**Re: Royal Rehabilitation Centre, Sydney –
Issue with retention of Tree 43.**

Copy of Site Plan
AR SK 1 03 A dated 03 December 2007
by Bates Smart.
Marked up by C. Mackenzie. This copy not to scale

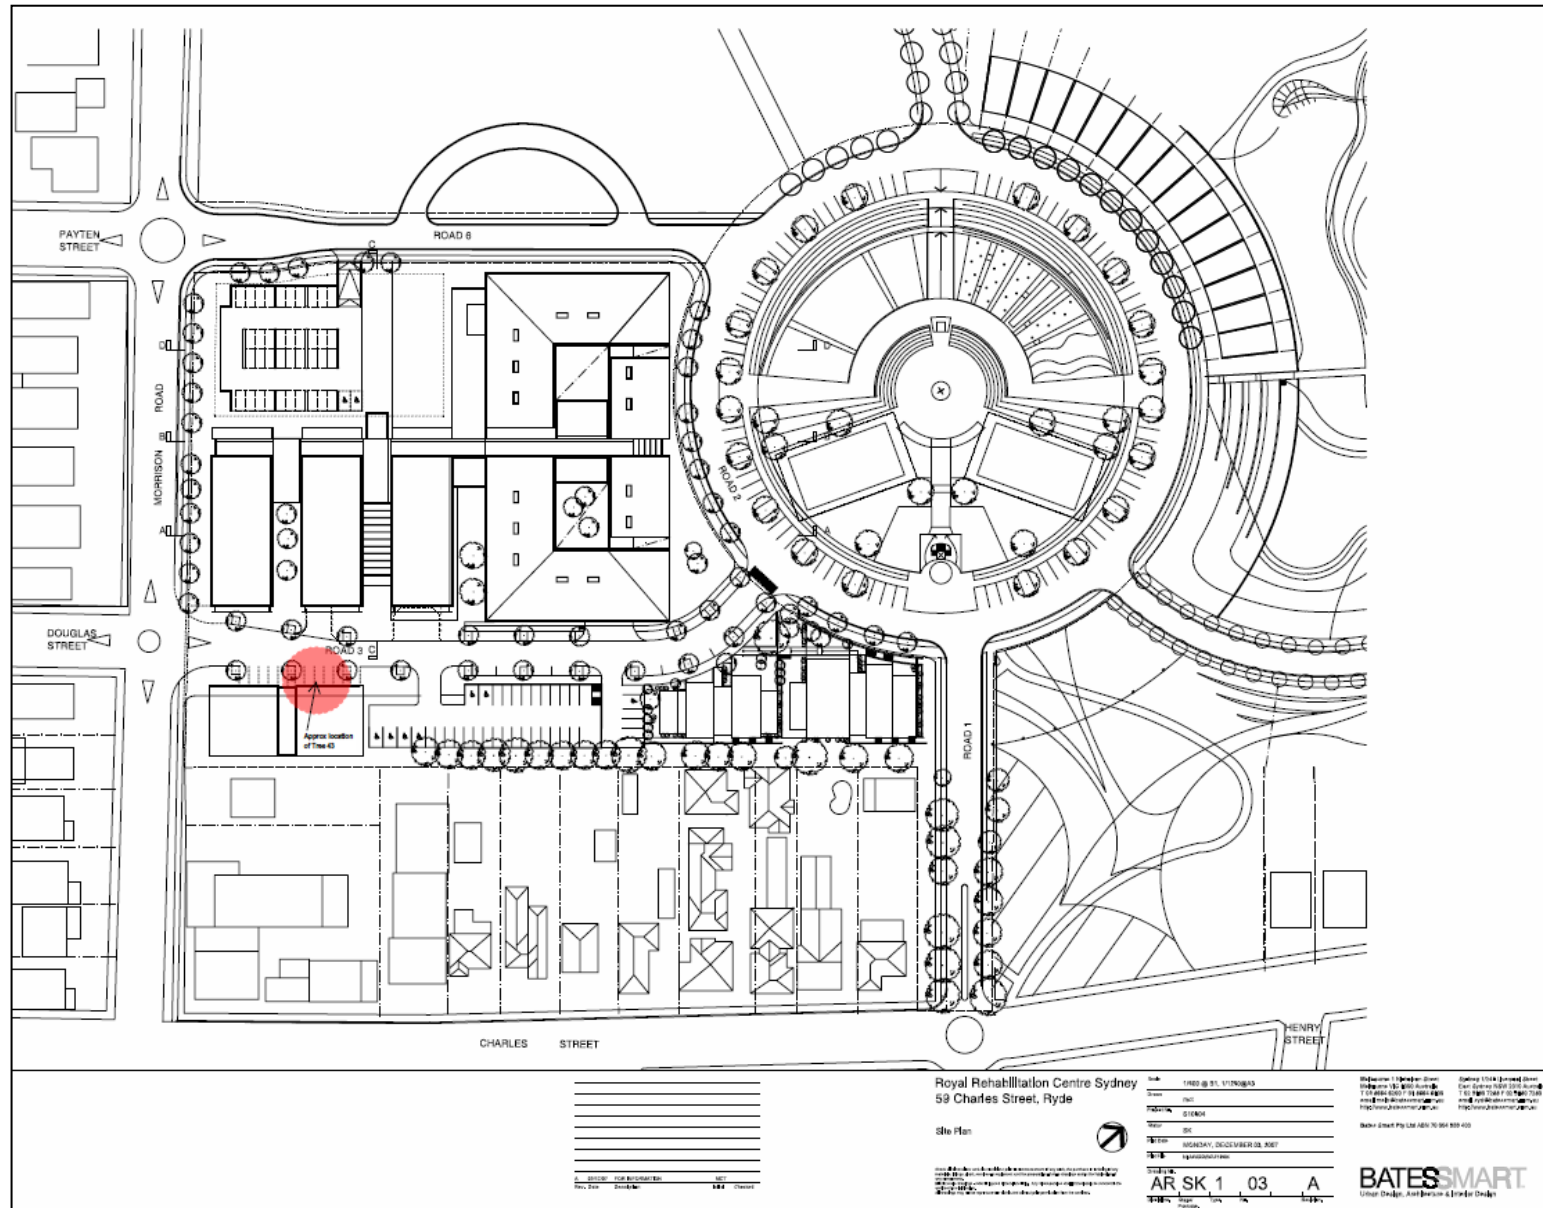
Note:
TREE IS NOT SHOWN TO BE
RETAINED ON PLAN
Red circle and arrow identifies
approximate location of tree.
